Subject: **Comcast Beaverton Generator**  
**CU2022-0011/DR2022-0135**

This letter provides responses to the Stormwater Report and Site Development Review comments in your November 3, 2022, review letter..

# Drainage Report

FIGURE 1.D - EXISTING STORMWATER FACILITIES

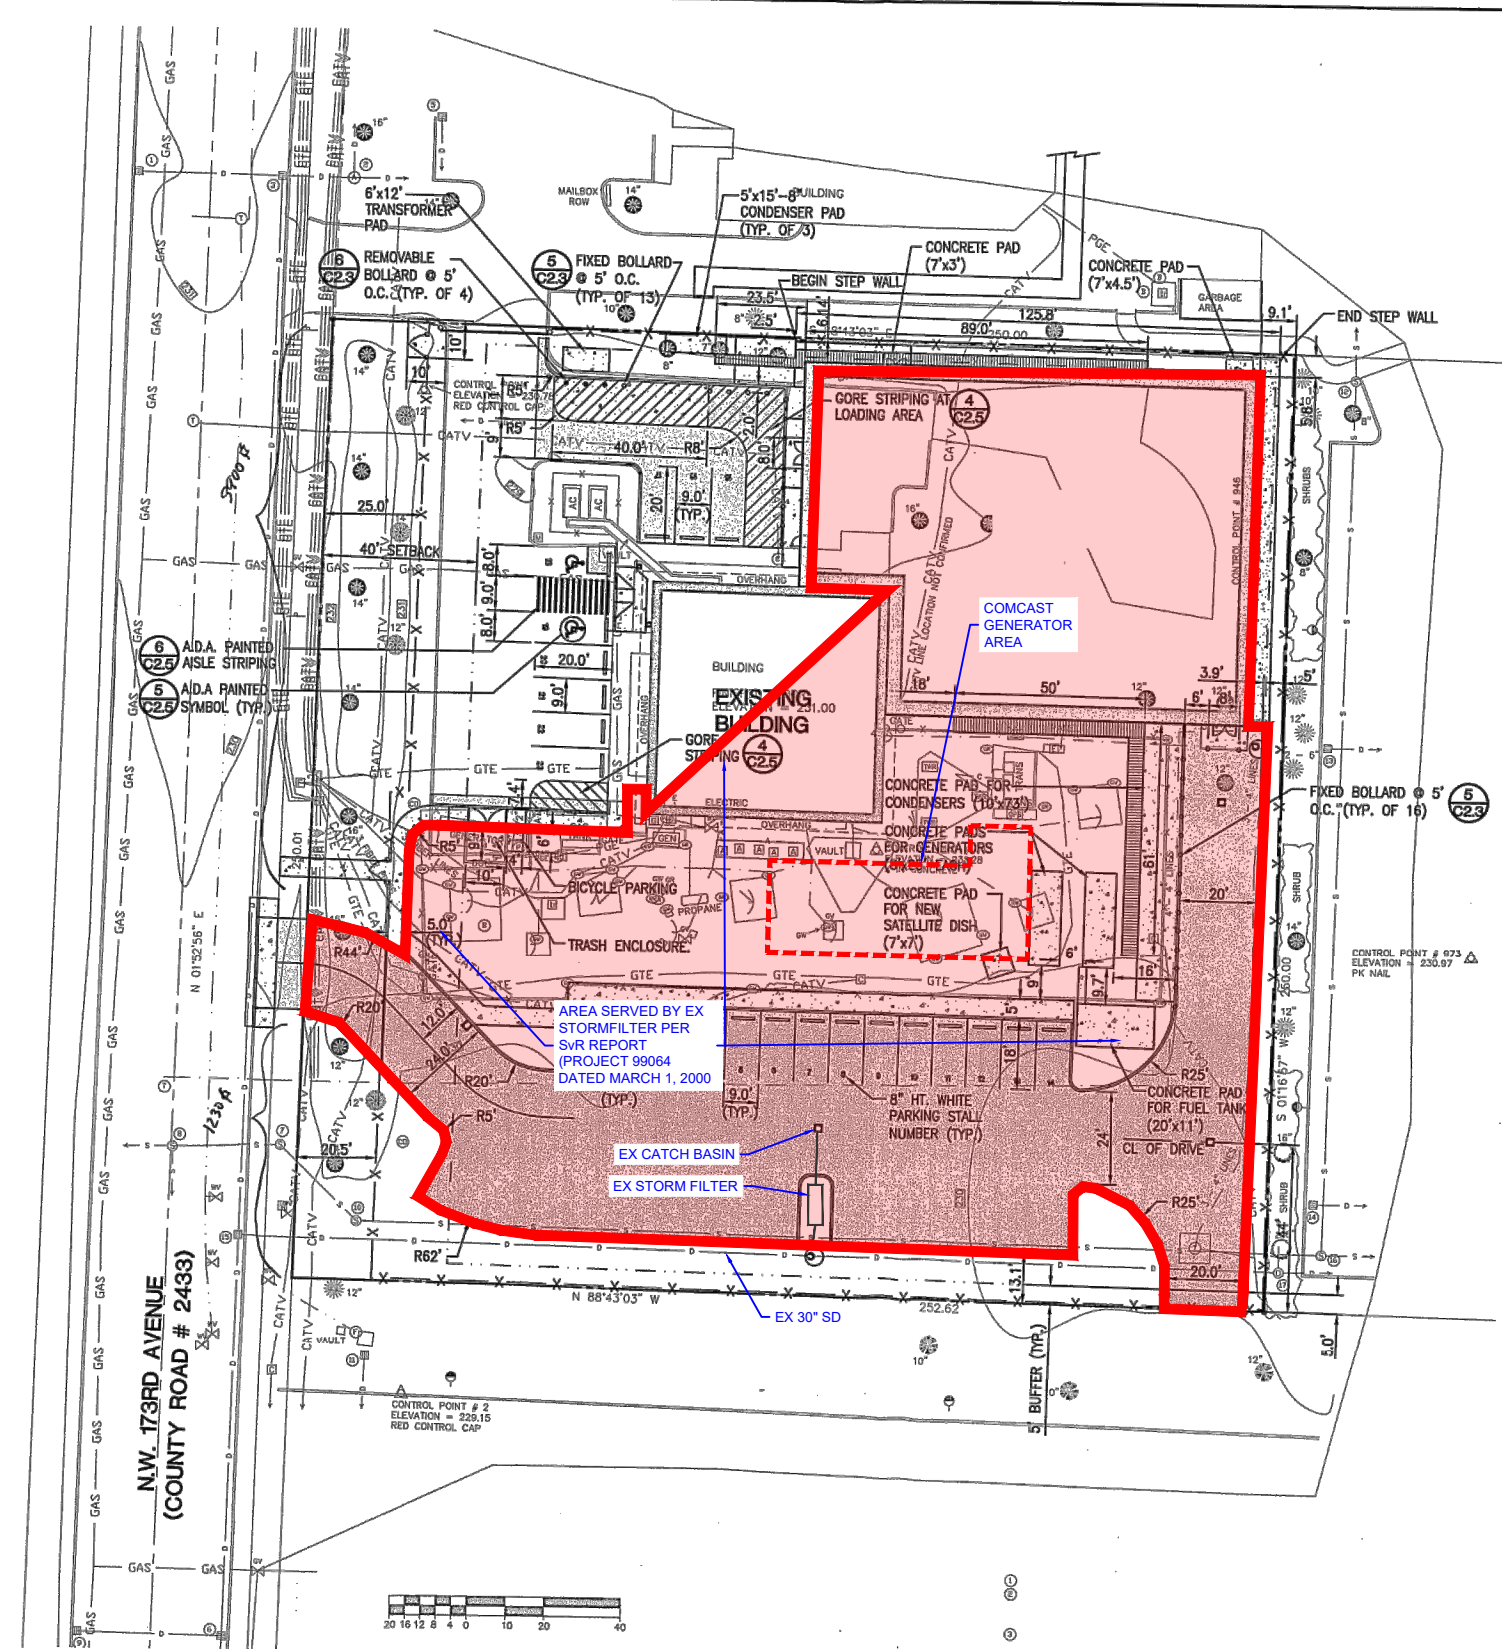
- a. Please show how the existing storm runoff from the onsite generator area is conveyed to the existing stormwater filter. The storm report shows that the existing storm filter treats this area, but it is unclear how runoff reaches the filter from areas other than the parking lot.

Response: Runoff from the proposed generator area sheet flows south across the rock surfacing and concrete slabs, over the sidewalk and then over the parking lot pavement to an existing catch basin in the middle of the parking lot. That catch basin is connected to the stormfilter with a 12-inch ductile iron pipe. See attached photo narrative.

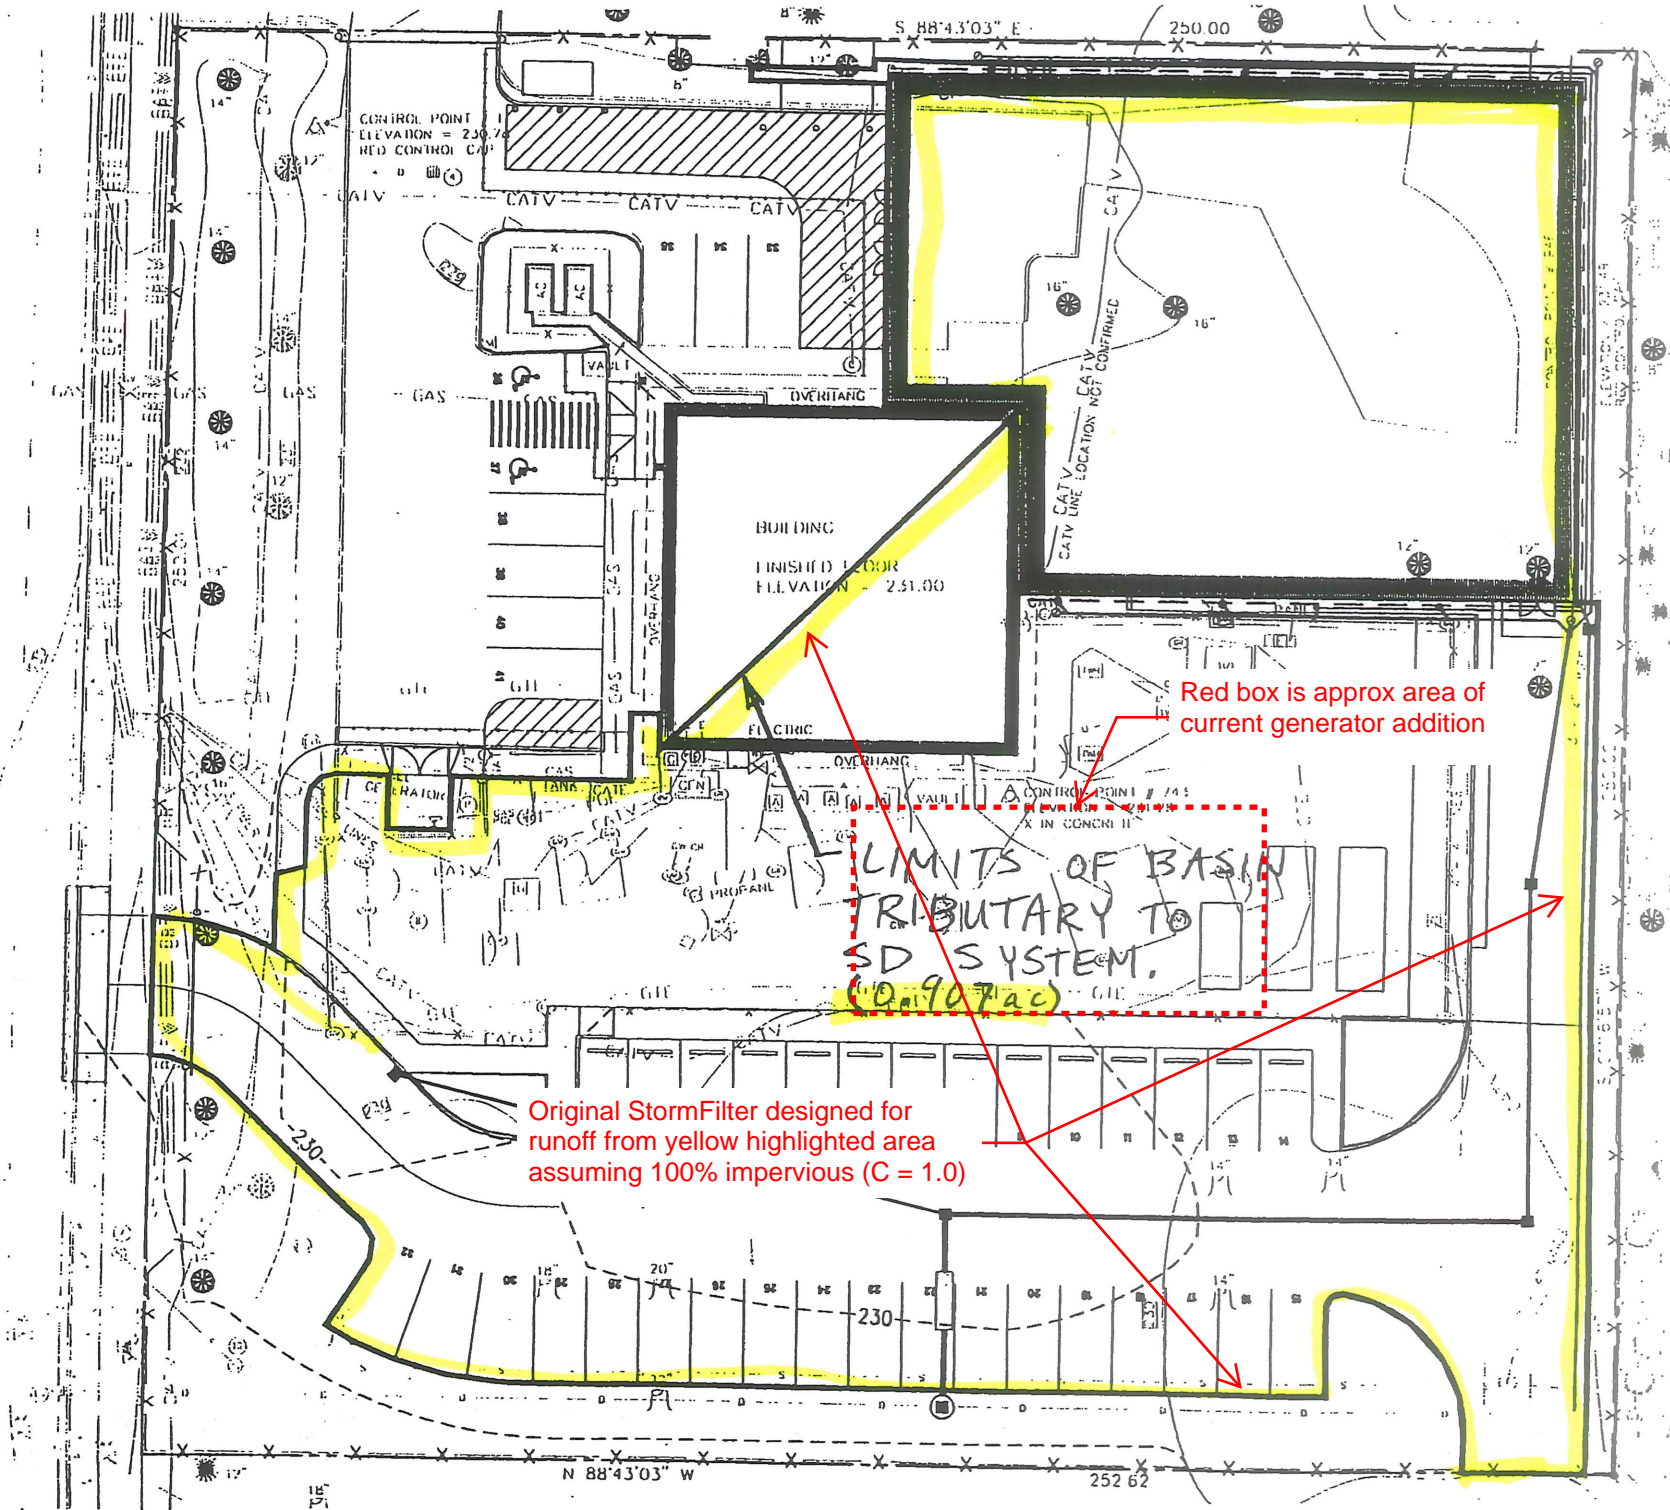
- b. Please provide calculations showing that the existing storm water filter is properly sized to treat the entire impervious area from the site.

Response: Sizing calculations for the existing stormfilter are contained in the Stormwater Site Plan report prepared by SvR for the previous development of the site. The cover page, stormfilter flow calculation and contributing area map from that report have been added as Appendix C to our stormwater report. The area of the current generator addition project is entirely within the 0.907 acre basin modeled for the stormfilter sizing. The calculations show the basin was modeled as 100% impervious (C = 1.0). Standard CWS water quality storm precipitation values were used.

Red box is approx area of  
current generator addition

Original StormFilter designed for  
runoff from yellow highlighted area  
assuming 100% impervious (C = 1.0)
